COMMITTEE OF ADJUSTMENT

MINOR VARIANCE REPORT

APPLICATION: A/060/2025

| <u>Owner (s)</u> | <u>Agent</u> | <u>Location of Land</u> |
|----------------------|--|---|
| MC OAKVILLAGE GP INC | Catherine McEwan Korsiak Urban Planning 277 Lakeshore Road East Rd #206 Oakville ON L6J 1H9 | PLAN 20M1211 BLK 8 3071 Trafalgar Rd Town of Oakville |

Figure 1 – Various photos of affected spaces

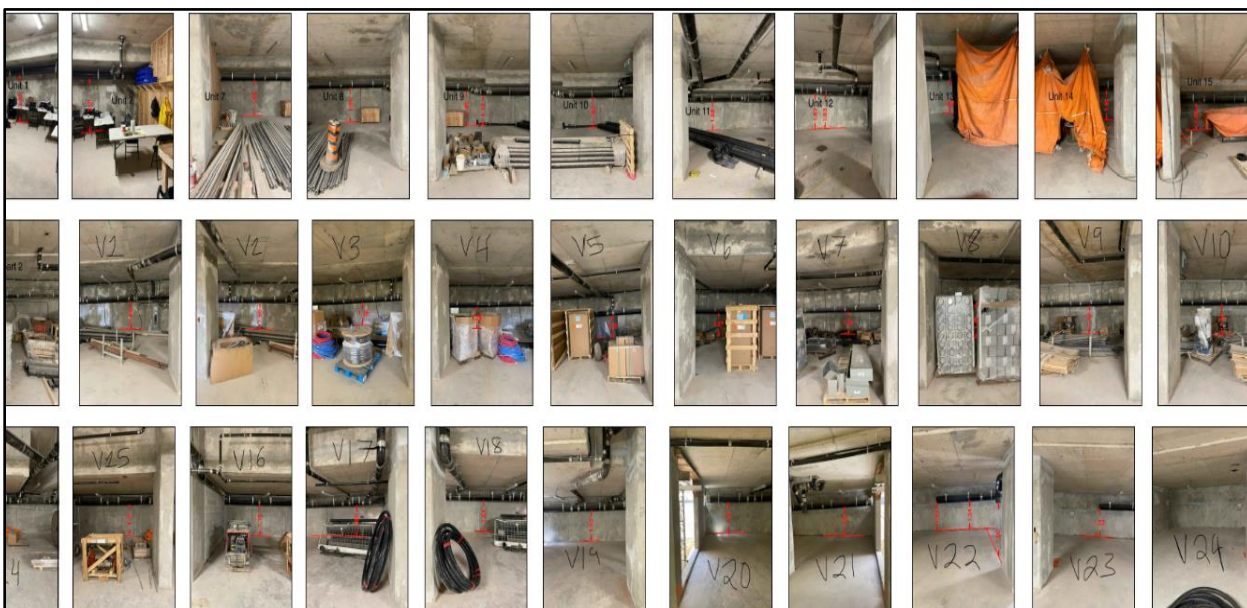
As indicated above the applicant is proposing the development of 378 residential units with underground at grade parking, for which detailed survey plans were submitted that identified the as-built non-compliant parking space dimensions, and parking aisle dimension. The variances are being sought due to the location of the servicing pipework which is encroaching into the required 2.1m headroom, more clearly demonstrated in the images provided below. Staff believe that the proposed variances compromise the functionality and safety of the parking spaces.

While the applicant submitted photos to show that the vehicle can physically fit, it does not equate to practical functionality and unlike previous variances we have dealt with involving dimensional reduction the quantitative reduction proposed result in qualitative impacts.

Although the applicant referenced in their application that there will be safety items to mitigate the damage, the applicant failed to provide examples of what the safety measures will look like. There is insufficient information on how potential damage to servicing pipes caused by vehicular movement will be addressed, specifically in regard to potential increases to condo fees due to maintenance and repairs, or how potential buyers will be informed of such damage due to the encroachment. As such, the proposal does not maintain the general intent and purpose of the Official Plan.

It is evident from the images above that the service pipes are in close proximity to the front end of parking vehicles. The positioning of the pipes and proposed variance increase safety risk to the servicing infrastructure and functionality, which could increase the likelihood of vehicle accidents. Such potential impacts could be:

It is staff's opinion that the proposal does not represent an appropriate development of the subject property as a fundamental redesign to relocate the pipes out of the affected parking area would be required to mitigate the impacts on the existing parking spaces and drive aisles.

Figure 3 - EV Charging Outlets

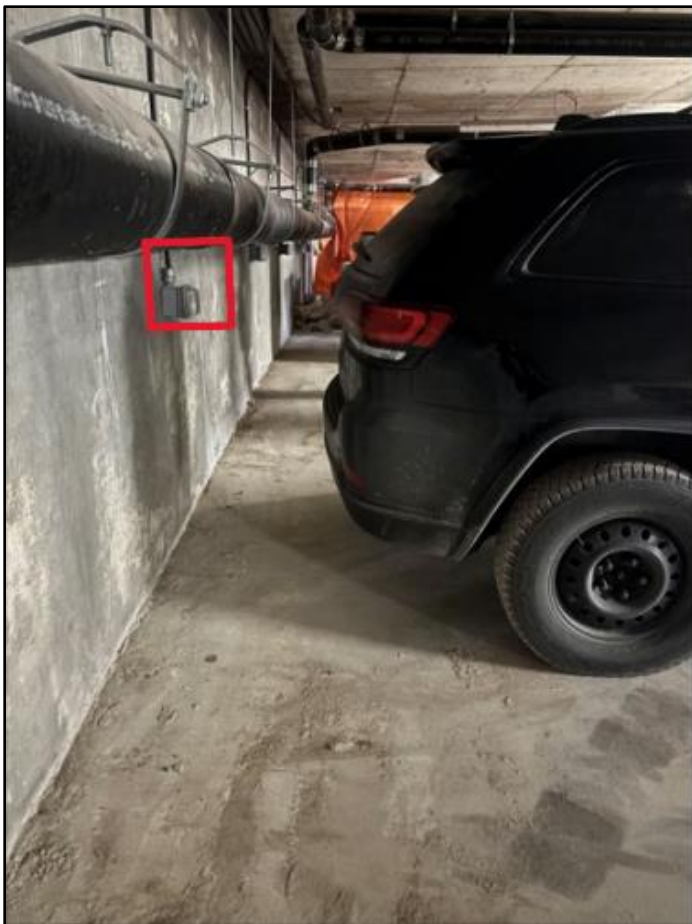
Additionally, it appears that there are EV charging outlets placed in the impacted parking stalls. It is staff's opinion that the reduced space will make it more difficult for drivers to properly position their vehicles and could cause drivers to overhang their vehicles further into the drive aisle.
